February 9, 2018

Melanie A. Bachman
Acting Executive Director
Connecticut Siting Council
Ten Franklin Square
New Britain, CT 06051

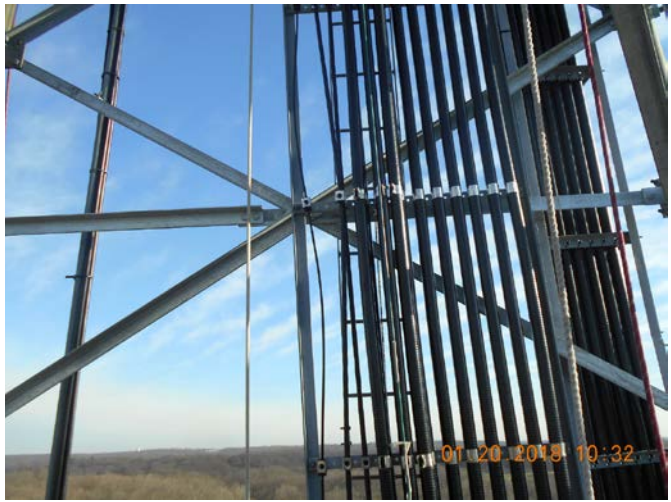
Comments: No deficiencies found.
